Engineering Handbook

AUTOMATIC OBSERVING (EHB-11)

MODIFICATION INDEX - AUTOB

SIZE	D	DRAWING NO.	5010-F3BVD1-DR001
SCALE		SHEET 1 OF 1	FILE

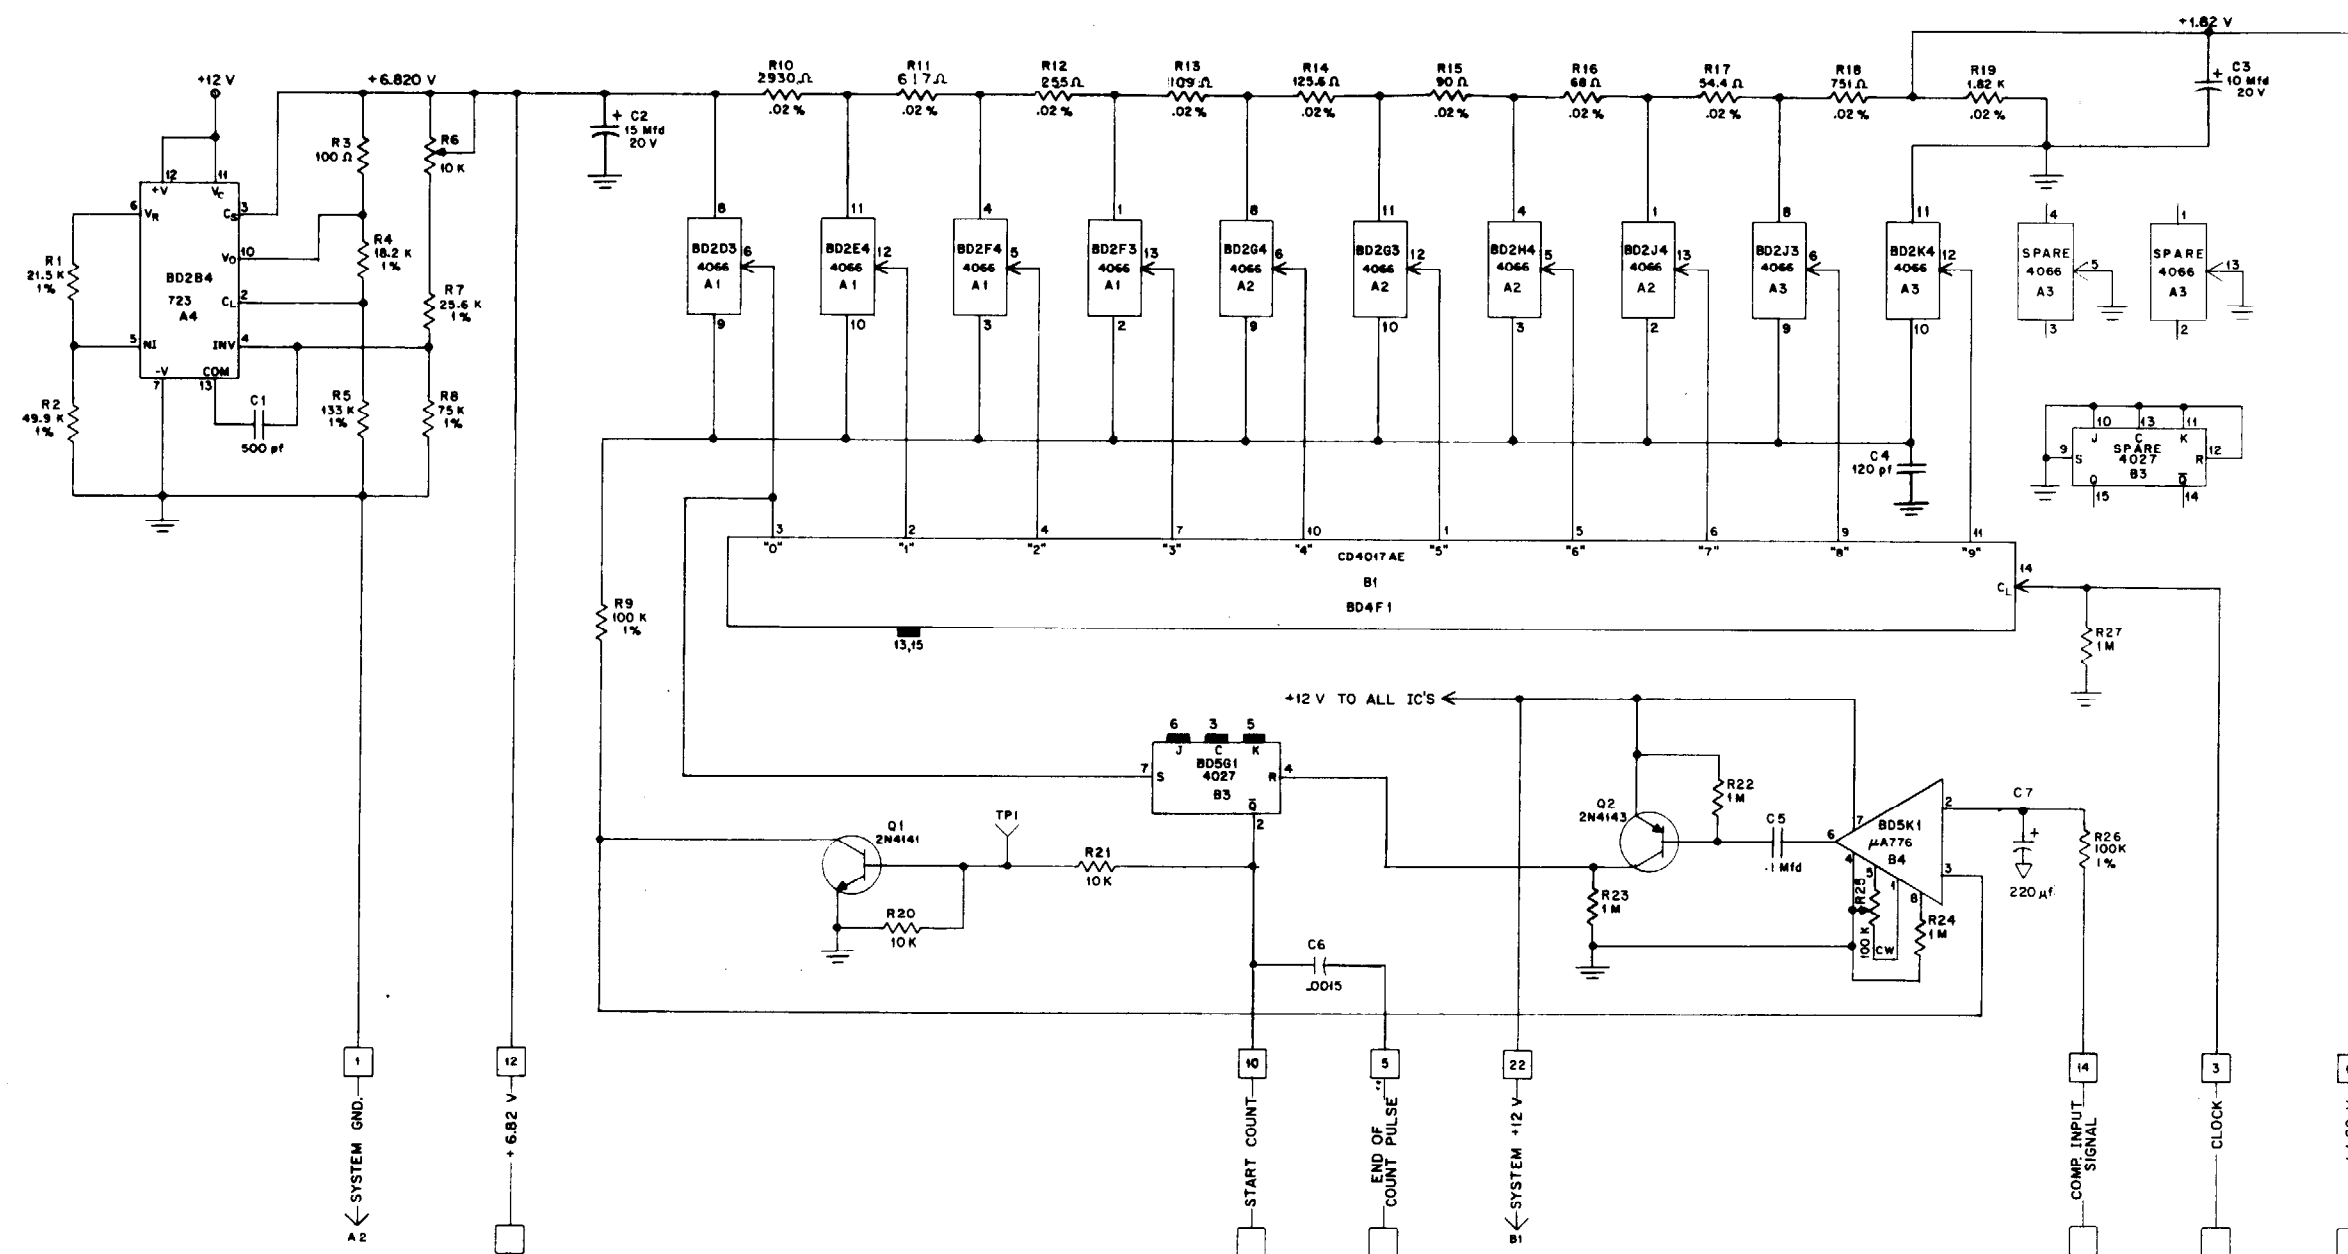
General: This modification to the Backscatter Visibility Sensor Digitizer in the Videograph will attenuate noise and smooth the output with the addition of C7, a 200 uf capacitor, at Pin 2 of B4.

Resistor values R10, R11, R12, and R13 were changed to comply with the FAA's request for the following thresholds of visibility:

With pen-and-ink, change resistor values of R10, R11, R12, and R13 to read 2930 ohms, 617 ohms, 255 ohms, and 109 ohms, respectively, on Drawing No. 510-1 Back-scatter Visibility Sensor Digitizer of the Fog Detector Videograph Manual. On same drawing, add capacitor C7, 220 uf at Pin 2 of B4; the positive side of capacitor going to OP amplifier and the negative indicating return. Change the values on the Parts List S010-F3BVD1-DR002 to conform with the above. Add Drawings S010-F3BVD-1-DR001 and DR002 to the Videograph Manual.

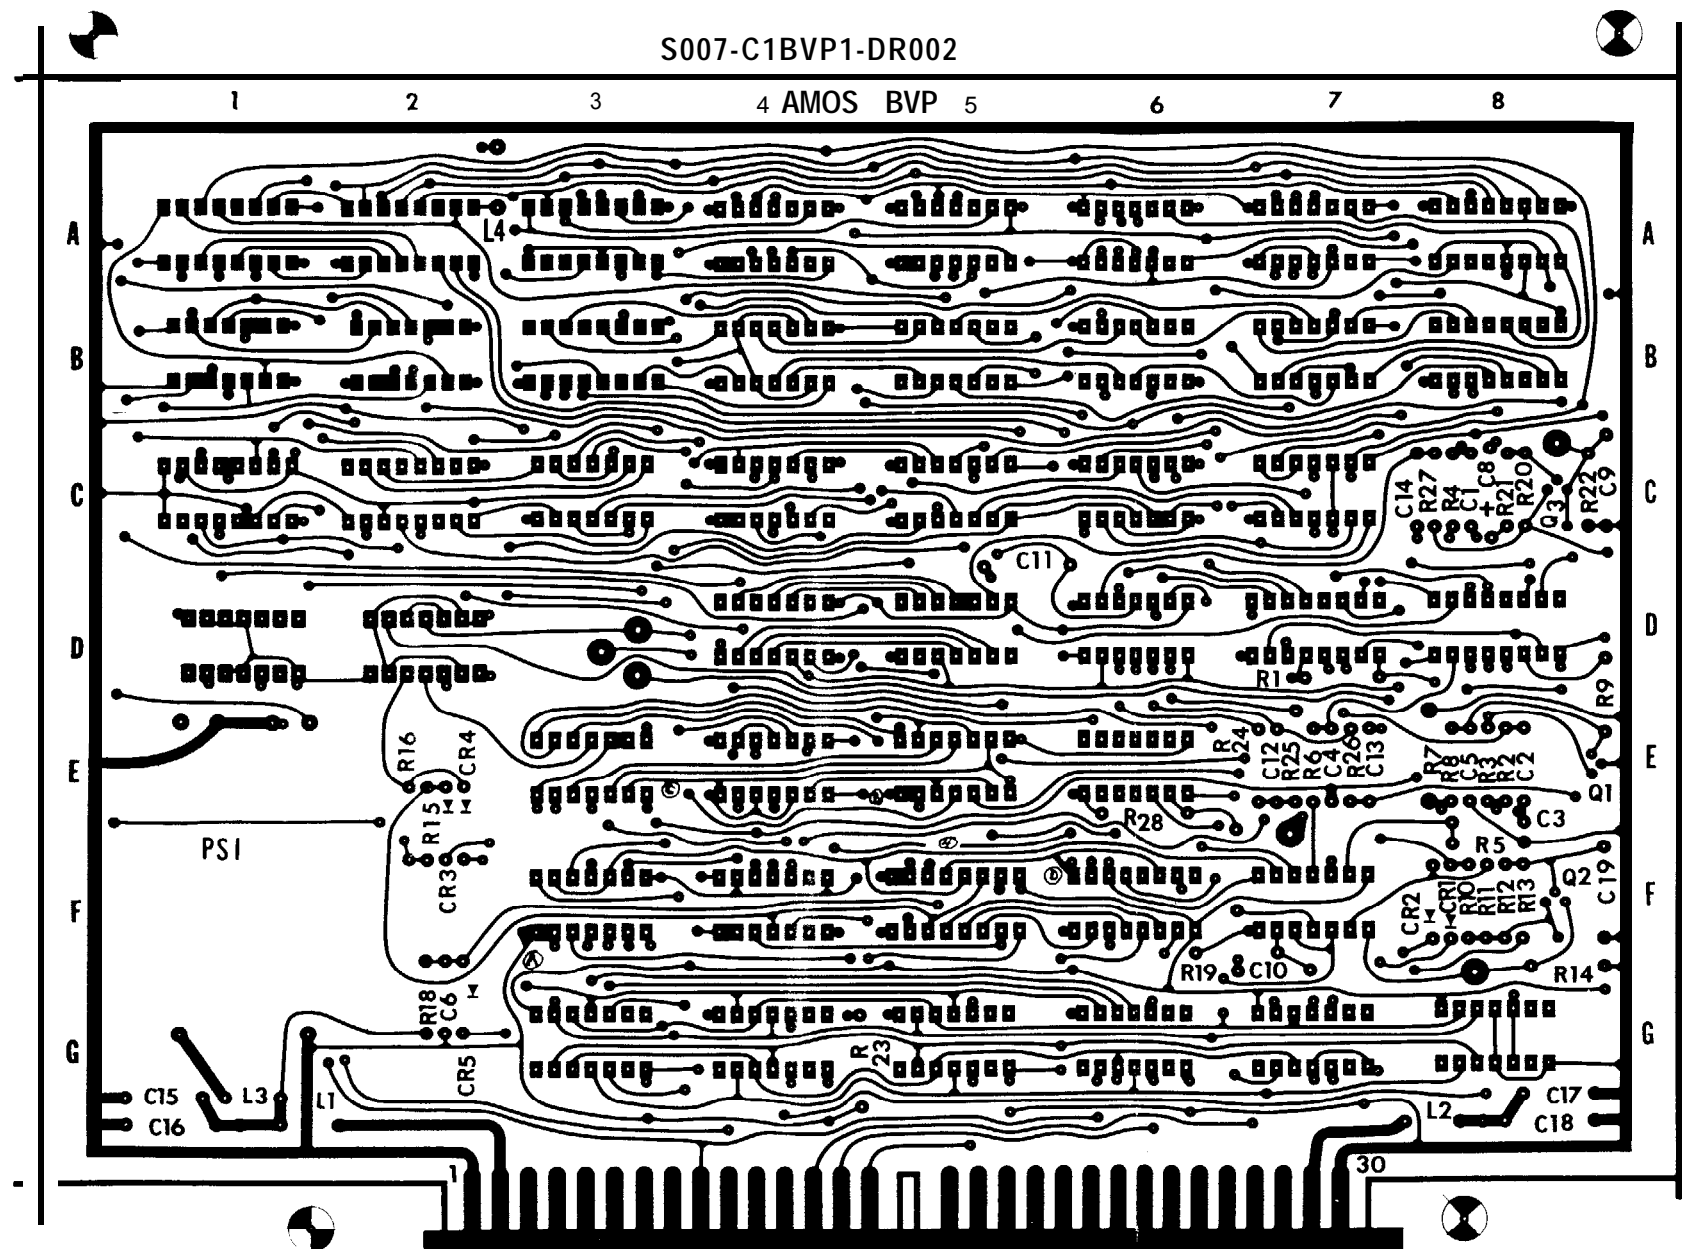
Remove Page A32 and replace with Page A32 Change I. Page 36, strike out the drawing at the top of page; add drawings No. S007-C1BVP-DR001, DR002, and AUTOB AMOS BVP Master Pattern (b).

MODEL 3132 DISCRIMINATOR MODIFICATION OF DRAWING #41352, SHEET 2

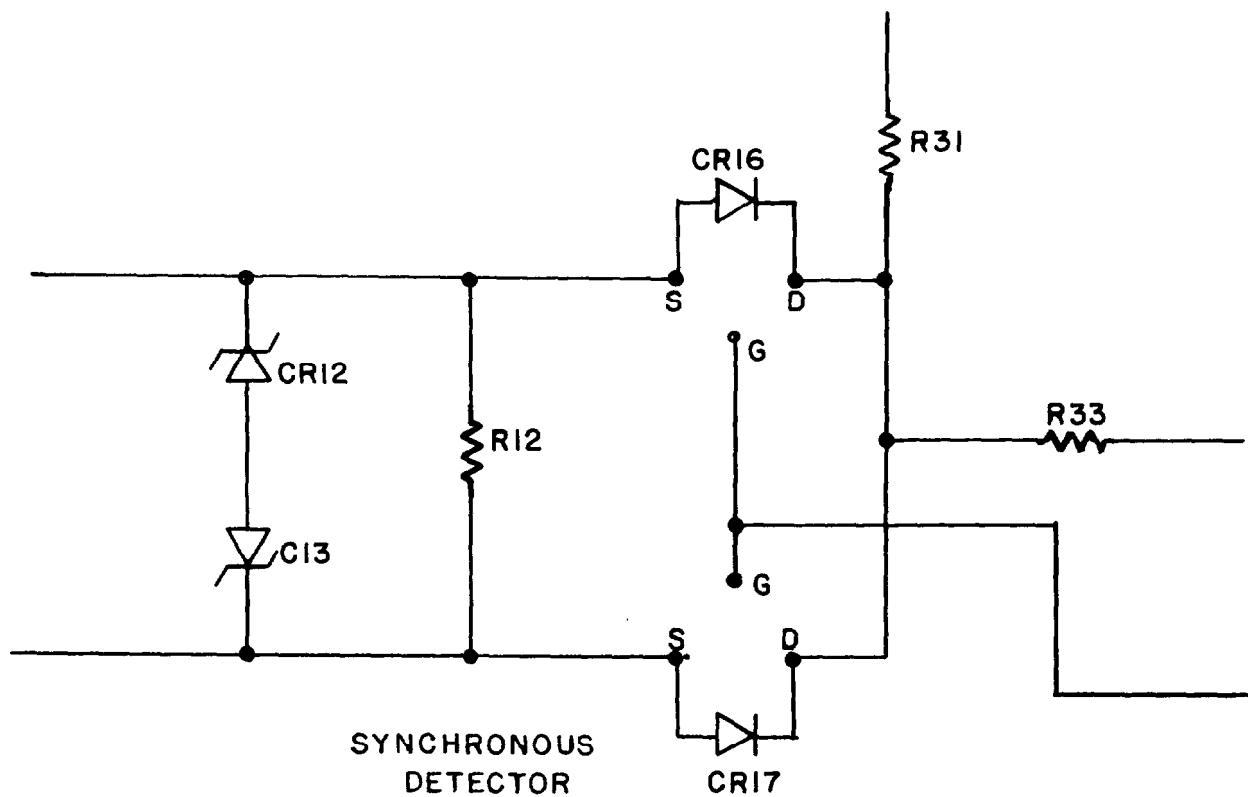
1. Remove the top and bottom cover plates from model 3132 discriminator. While consulting the schematic at the end of the discriminator manual (Drawing No. 41352, Sheet 2), locate transistors Q7 and Q8. Carefully unsolder these FETs and remove from board.
2. See Figure 1. Solder the cathode of one of the supplied 1N277 germanium diodes to the vacated source terminal pad of Q7. Solder the cathode of the second 1N277, the source pad of Q8 on the PCB. Solder the anode to the drain terminal pad.

With pen-and-ink refer to Manual 8-118, Ithaco Discriminator Model 3120, Drawing No. 41352, Sheet 2. Change drawing as per Figure 1. On Page 6-5, strike out Q7 and Q8. On Page 6-4 under reference designation, add CR16 and CR17. Under description, add Diode. Under part number, add 1N277 or 1N48.

F I G U R E 1

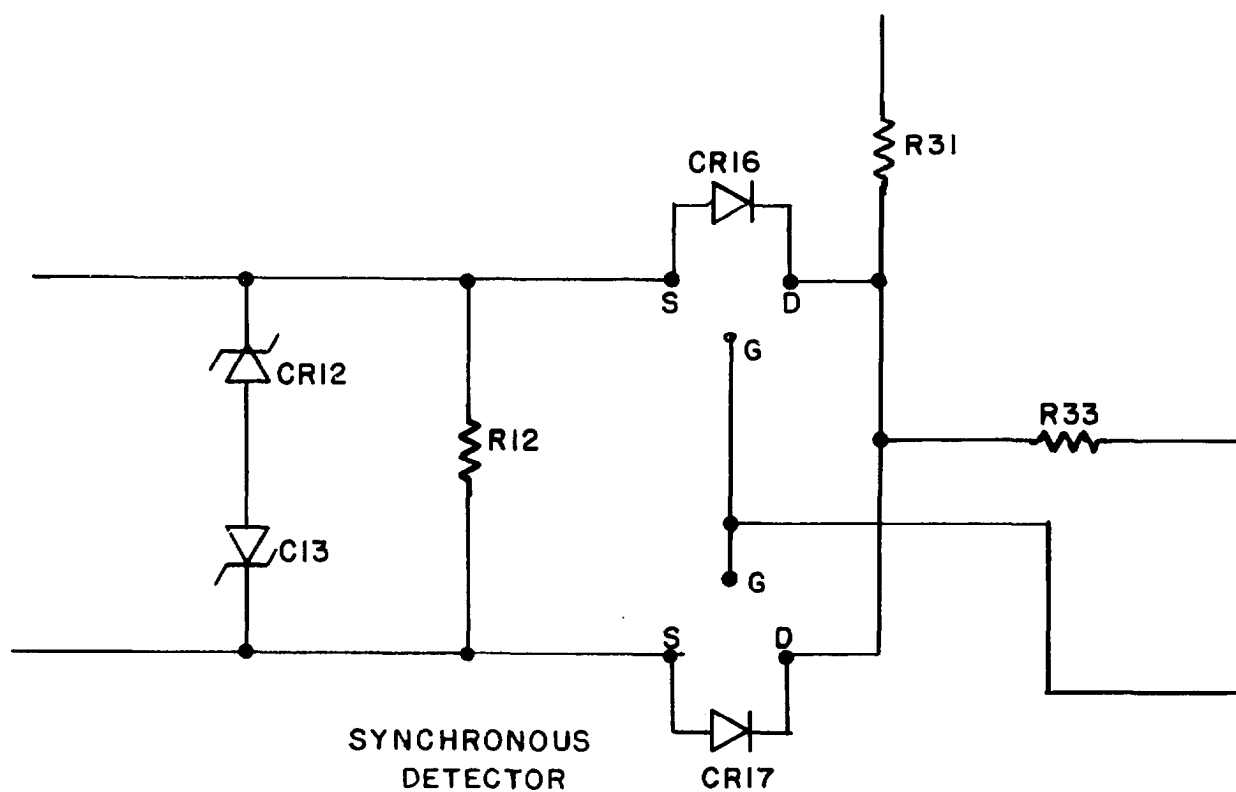
1. Remove the top and bottom cover plates from model 3132 discriminator. While consulting the schematic at the end of the discriminator manual (Drawing No. 41352, Sheet 2), locate transistors Q7 and Q8. Carefully unsolder these FETs and remove from board.
2. See Figure 1. Solder the cathode of one of the supplied 1N277 germanium diodes to the vacated source terminal pad of Q7. Solder the cathode of the second 1N277, the source pad of Q8 on the PCB. Solder the anode to the drain terminal pad.

With pen-and-ink refer to Manual 8-118, Ithaco Discriminator Model 3120, Drawing No. 41352, Sheet 2. Change drawing as per Figure 1. On Page 6-5, strike out Q7 and Q8. On Page 6-4 under reference designation, add CR16 and CR17. Under description, add Diode. Under part number, add 1N277 or 1N48.
